Lexington Planning Board

Wednesday, September 21, 2022

95 Hayden Ave. & 128 Spring St. (99 Hayden Ave.) - Continued Public Hearing for Major Site Plan Review

**DECISION OF THE LEXINGTON PLANNING BOARD
MAJOR SITE PLAN REVIEW**

EXISTING CONDITIONS PLANS (C3.1, C3.4, C3.5)

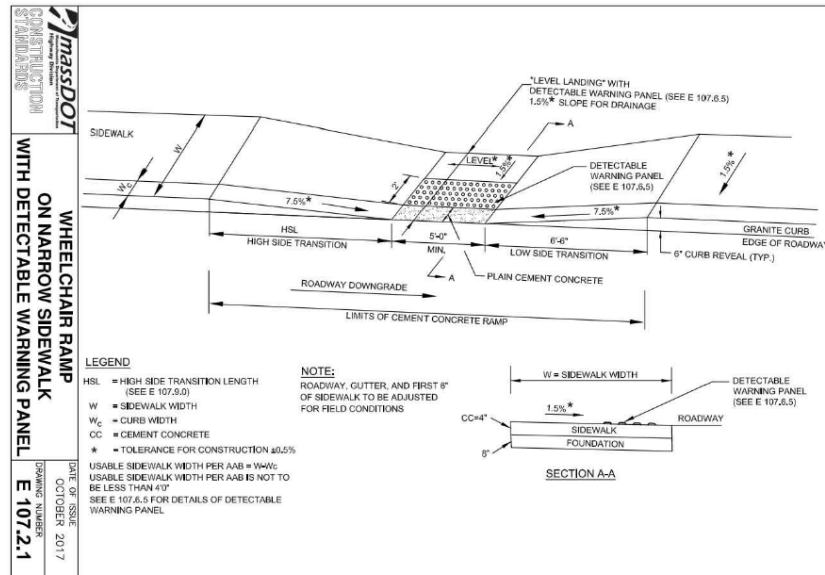
- Added borehole locations from Geotechnical Report by Haley & Aldrich
- Added surface, groundwater, and ledge elevations to the test pits and boreholes in the vicinity of the proposed subsurface stormwater infiltration facilities

- Removed portion of existing stone walls on at Spring Street entrance
- Barrier extension on Spring Street
- Added level landing pads, detectable warning pads, and accessible ramps to Spring Street crosswalk area

CONSTRUCTION DETAILS 3 (C11.3)

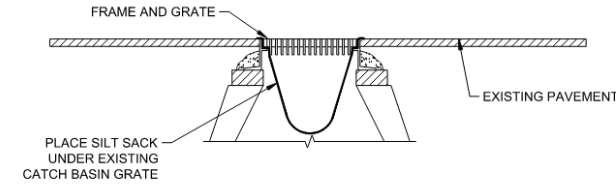
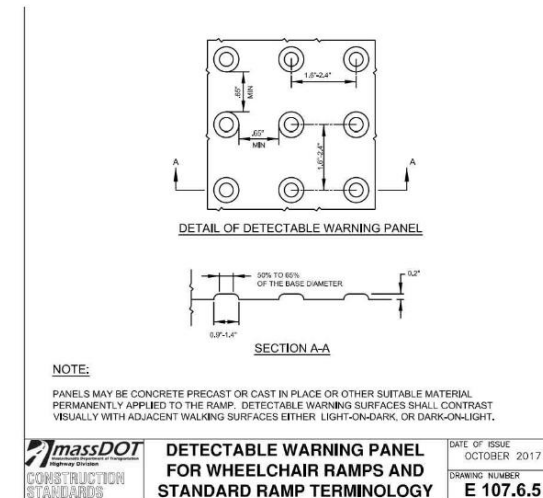
- Added MassDOT ramp and detectable warning pad details for the Spring Street crosswalk area
- Added notes to catch basin silt sack detail regarding silt removal and inspection to prevent overflow

97 HAYDEN AVE - FLOOR PLANS (A1.1)

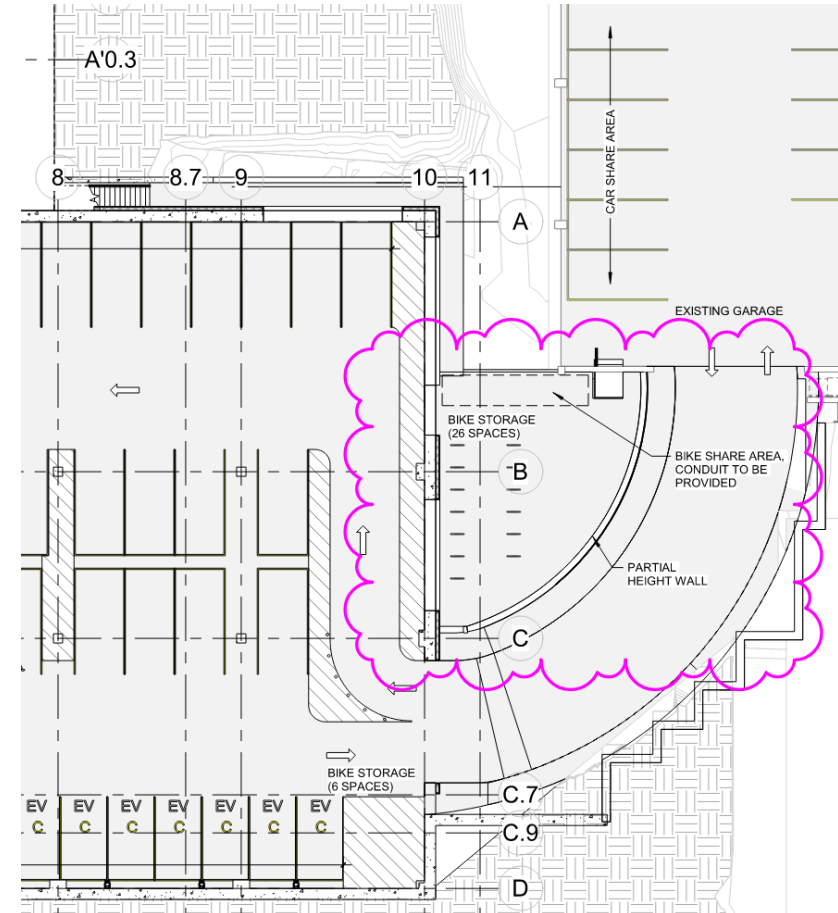
- Building 1 Parking Level
 - Added partial wall barrier between driving lane and bicycle storage area
 - Revised bicycle racks to allow for double sided parking (spaced 4' apart)
- Building 1 Ground Level
 - Added 7 double sided bicycle racks (totaling 14 bicycle parking spaces) to maintain the total of 40 enclosed bicycle parking spaces for Building 1 (26 spaces on the parking level, 14 spaces on the ground level)
- Added automatic interior shade locations
- Added car share parking area location in existing garage
- Labelled EV parking spaces and future EV spaces on all floor plans

101 HAYDEN AVE - FLOOR PLANS (A2.1)

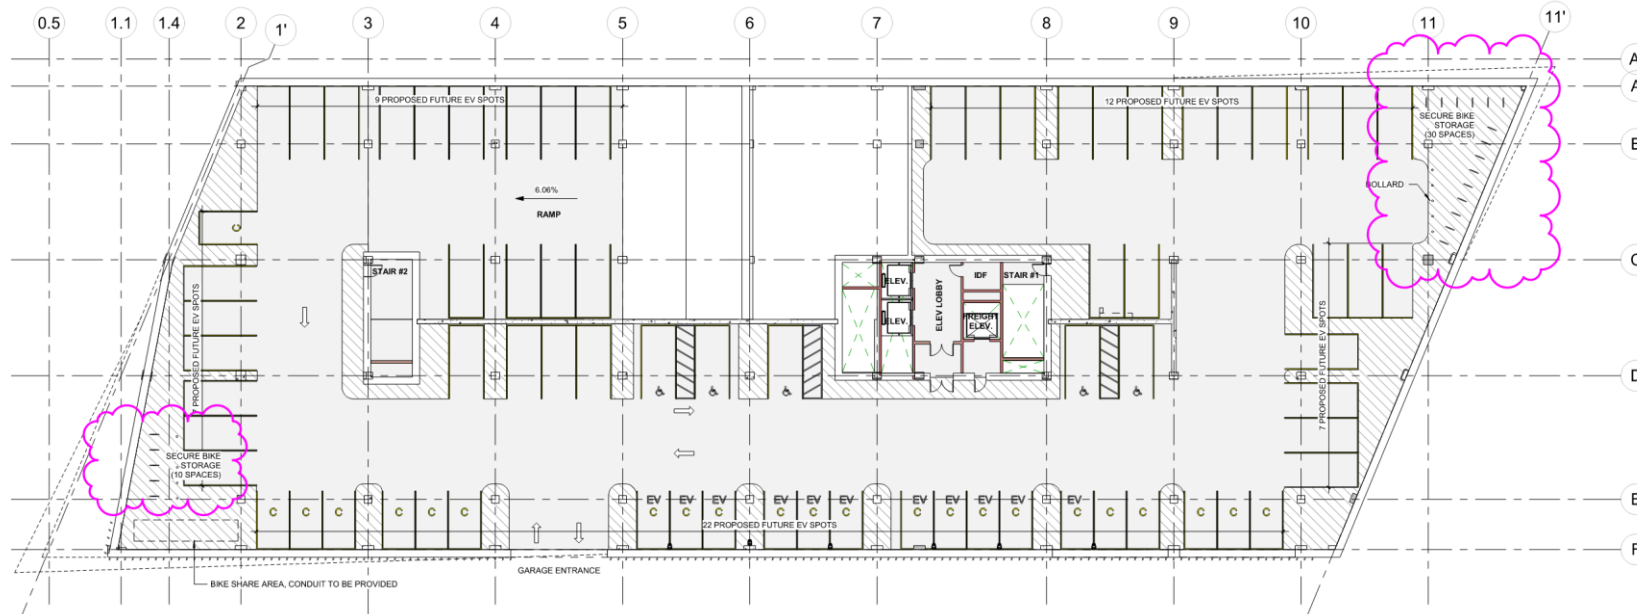
- Building 2 Level P3
 - Added bollards to protect bicycle racks
 - Revised bicycle racks to allow for double sided parking (spaced 4' apart)
 - Added 5 double sided bicycle racks (totaling 10 bicycle parking spaces) in the southwest corner to maintain the total of 40 enclosed bicycle parking spaces for Building 2 (30 spaces in the northeast corner, 10 spaces in the southwest corner)
- Labelled EV parking spaces and future EV spaces on all floor plans

LIGHTING DETAILS & PHOTOMETRIC PLANS (AL1.1 - AL3.1)

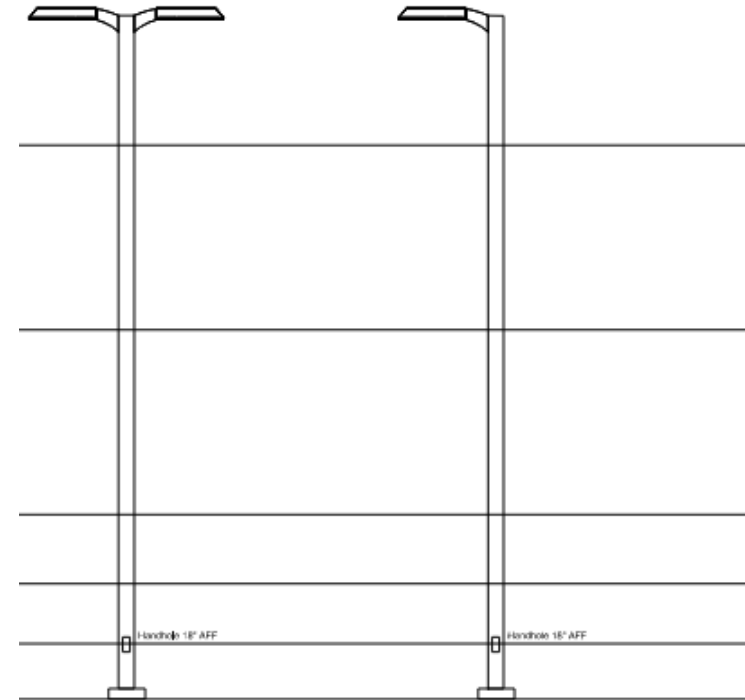
- Reduced light levels for the rooftop garage to an average of 1 footcandle via revised light fixtures
- The revised light fixtures have a lower light output (5,000 lumen 40w), mounted on an 18 foot pole (reduced from 20 foot pole in initial filing)

Figure 1:

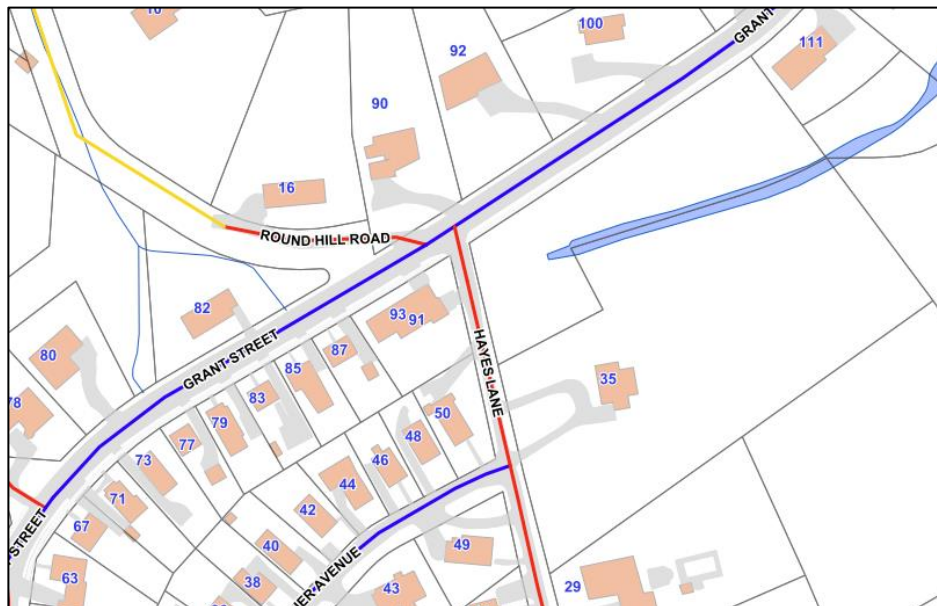
Fire observed the significant street trees, but would like the road widened to the maximum amount possible, without compromising the trees or their roots.

Planning Staff observed numerous mature street trees on either side of Hayes Lane. Planning staff supports a waiver to waive the 20' width requirement, and to allow the existing 14' width to remain, as the roadway also falls within a 200' riverfront buffer, and as the current pavement is in very good condition, with cape cod berms present. (See photos below of street trees and pavement condition). If the road were to be widened, work would happen within the drip line so it is likely that the tree's roots would be compromised.
